**Re: ODOARDI – Vacant Lot
22 Nethermont Ave. – New House Construction
Tax ID: Section 122.16 – Block 4 – Lot 7**

This letter accompanies a revision to the plans, in response to the draft resolution received from the Planning Board Staff and Town Consulting Engineer.

Site Plan and Tree Removal Permit Approvals for

Odoardi [19-039]

STAGING, EROSION CONTROL AND UTILITY PLAN

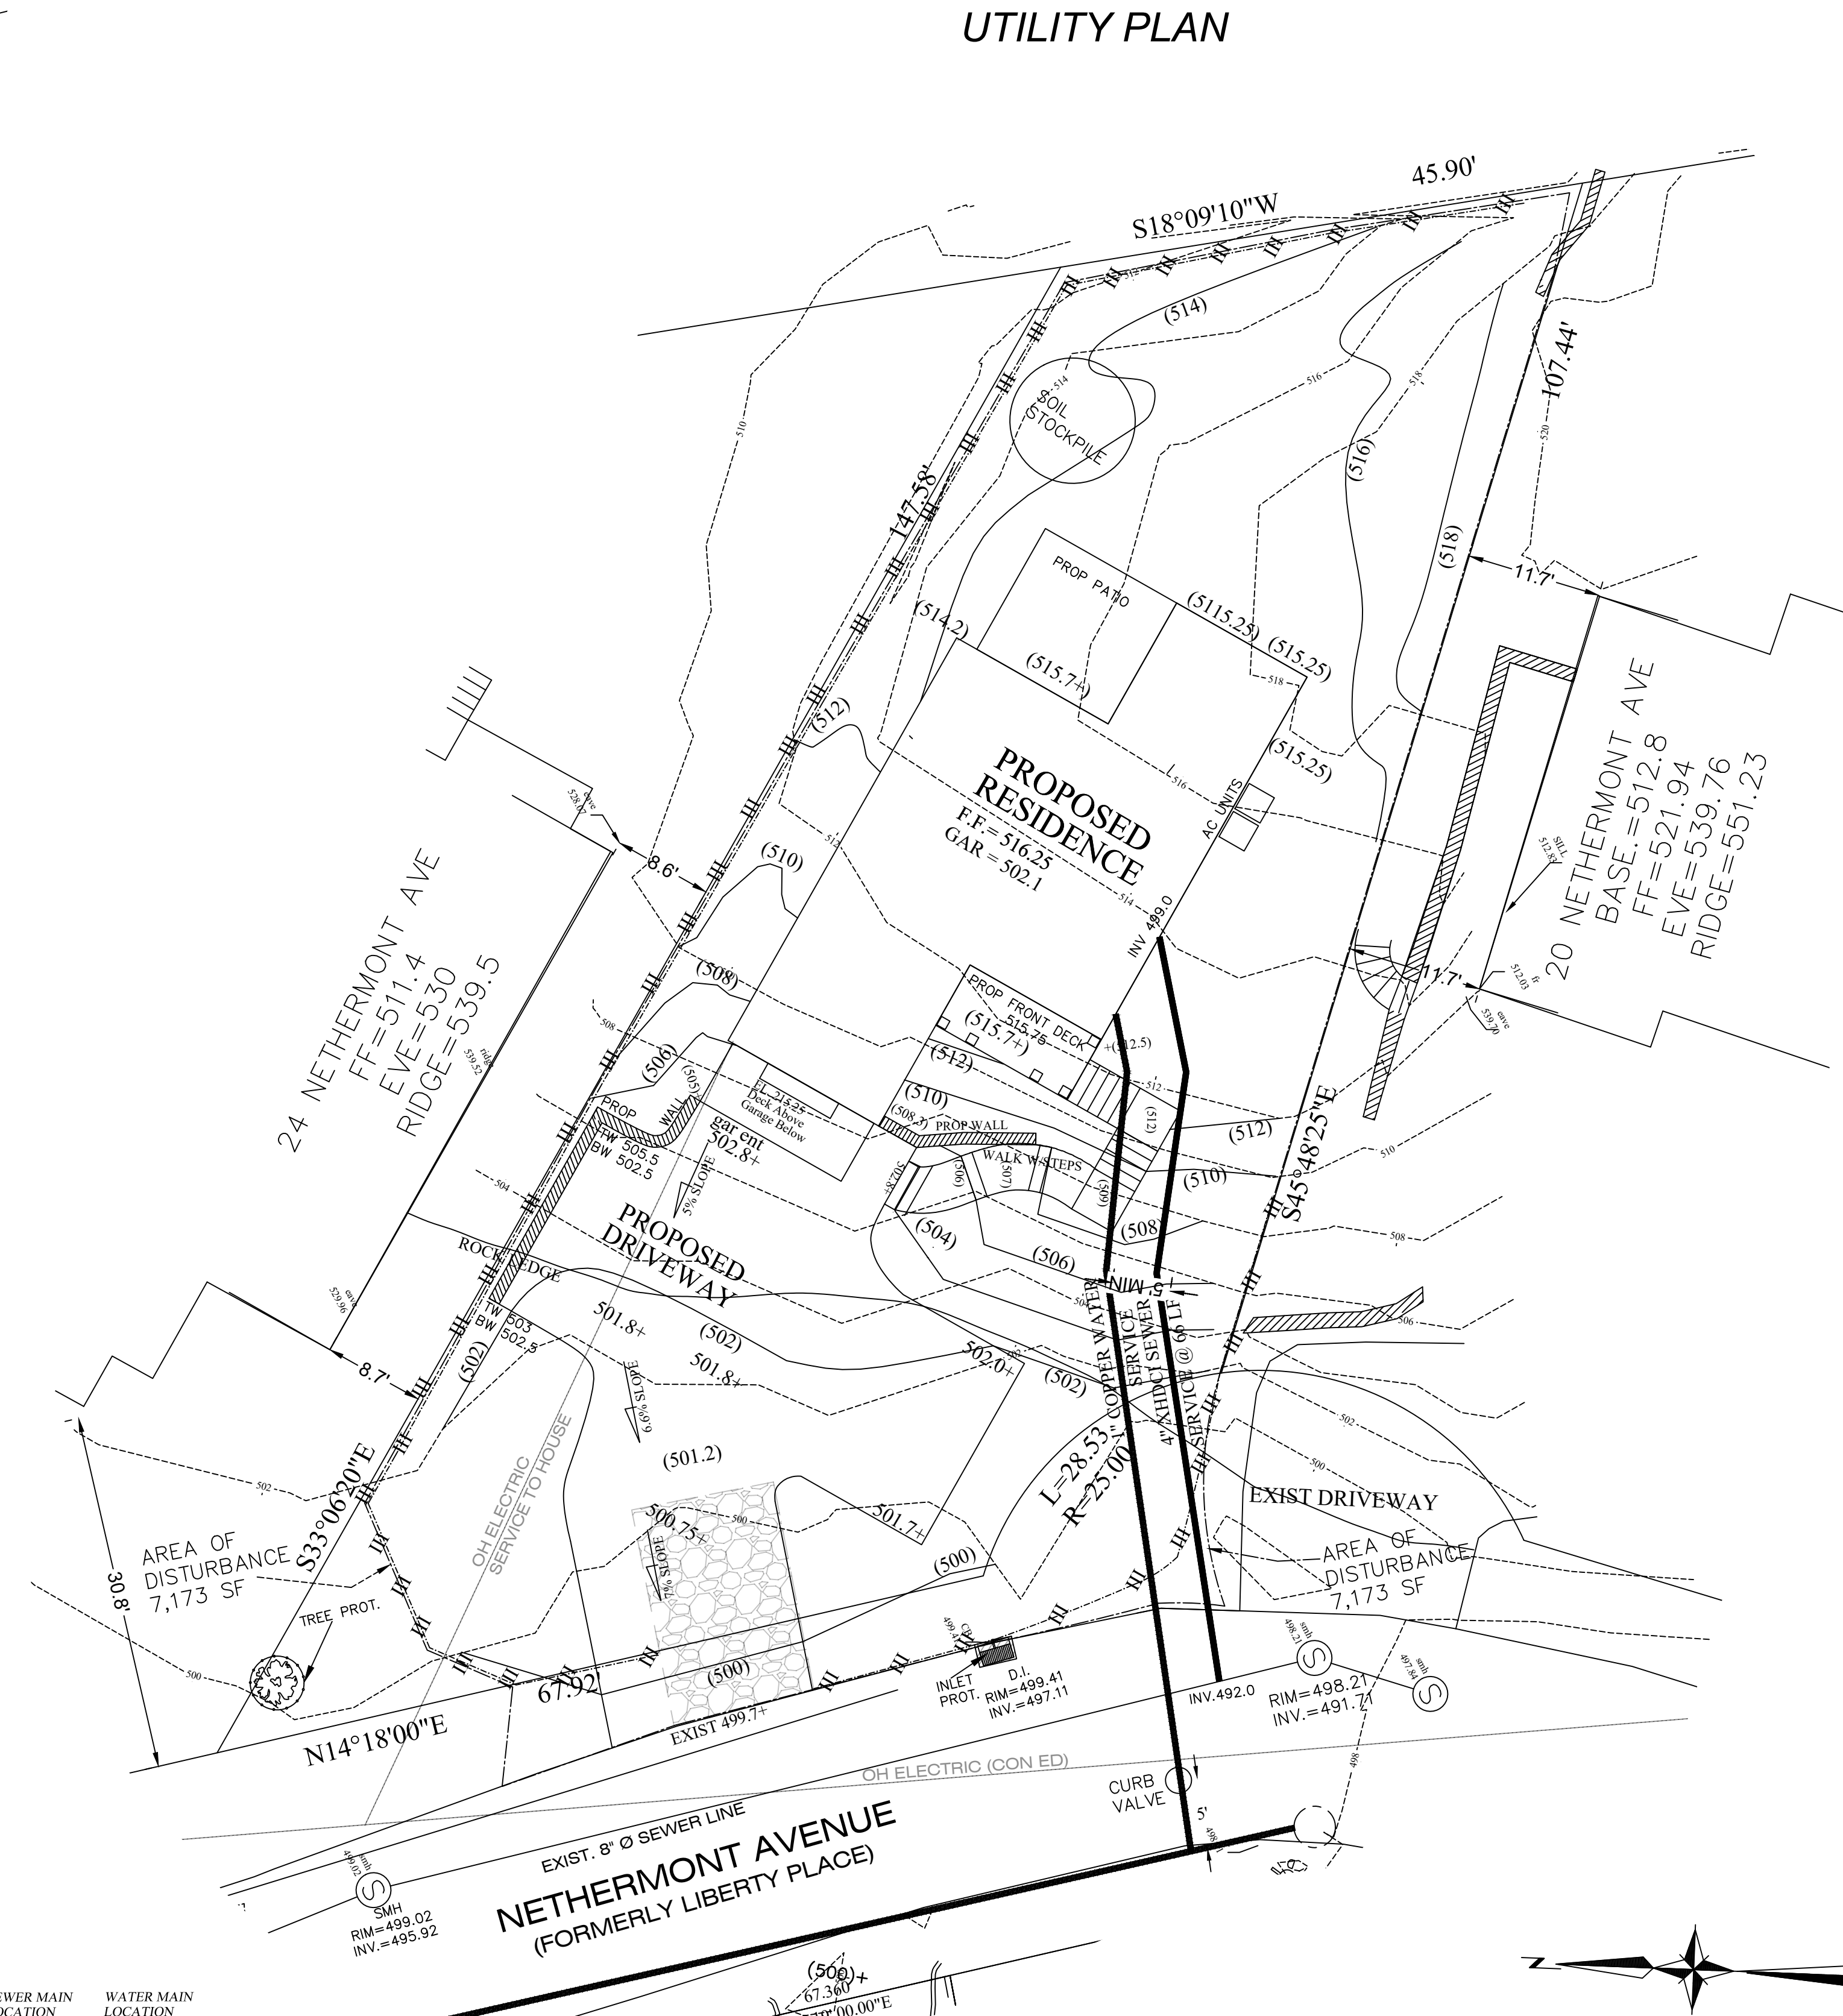
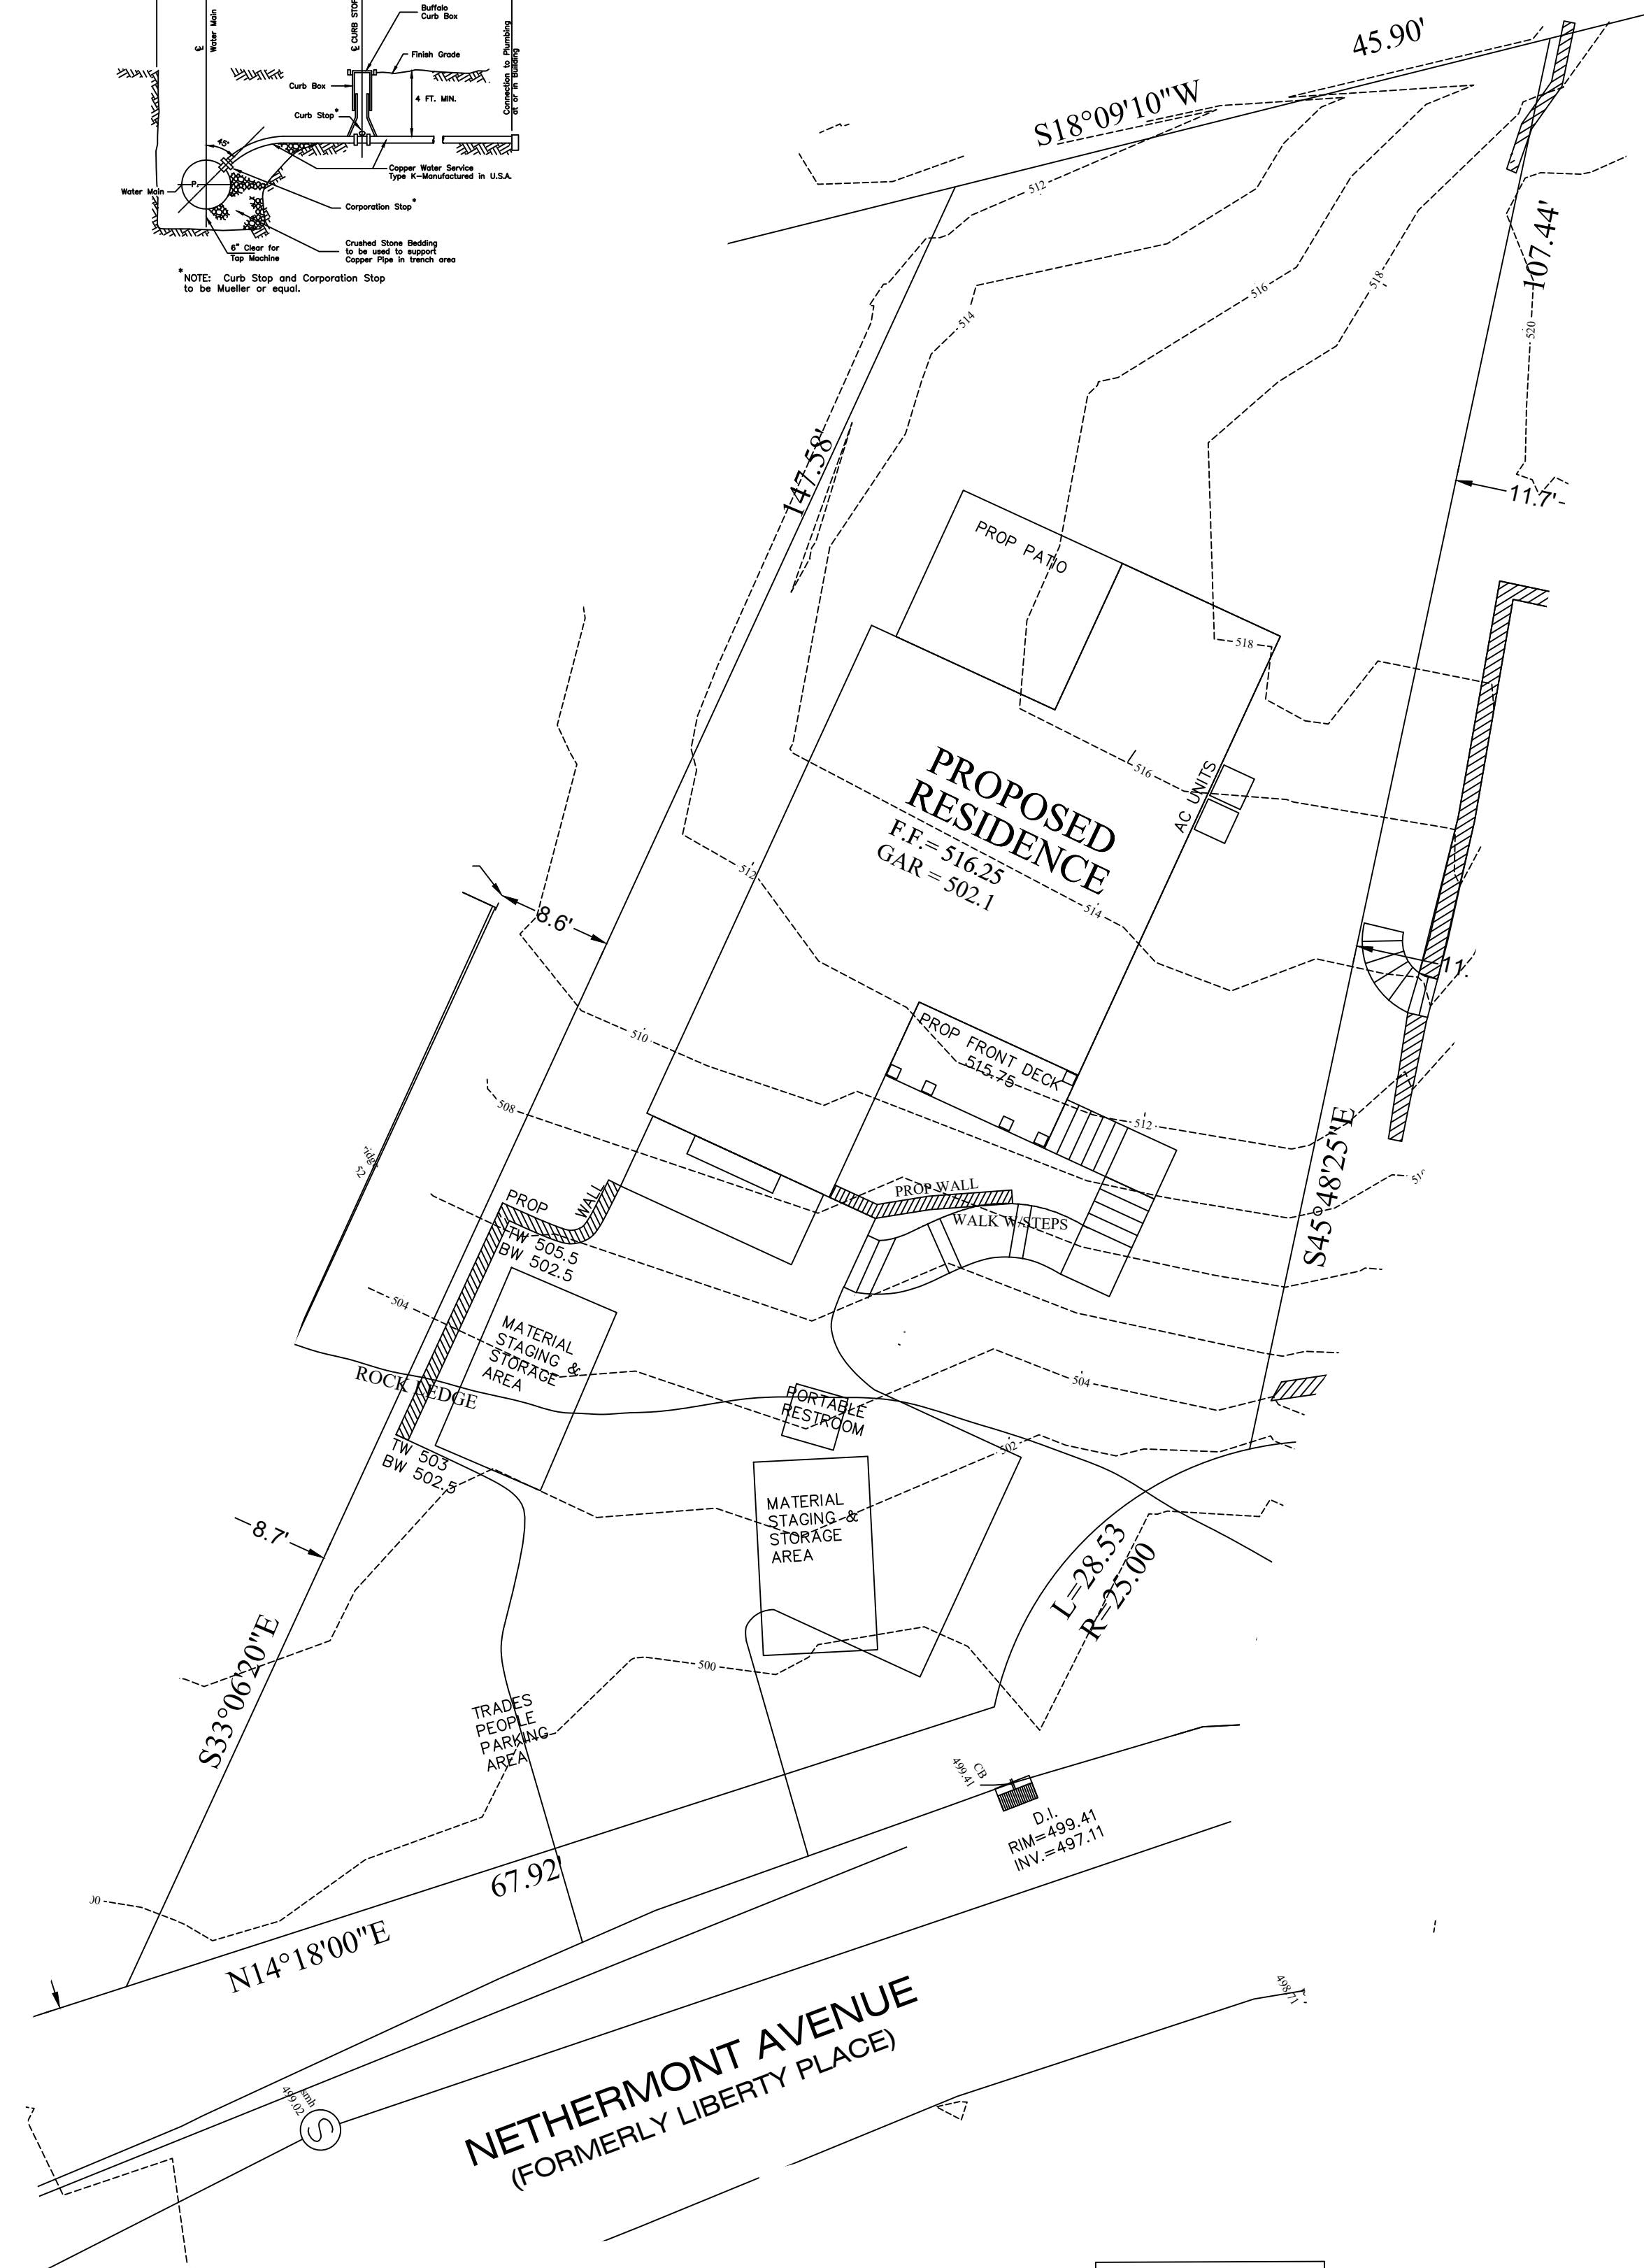
- _____ 10. Erosion control measures shall be illustrated on the plan, including, but not limited to, inlet protection, and tree protection to the satisfaction of the Town Engineer. The limit of disturbance shall be revised to illustrate and quantify all areas of disturbance on and off site.

All erosion control measures are shown on the Staging Erosion Control and Utility Plan Sheet 7 of 7.
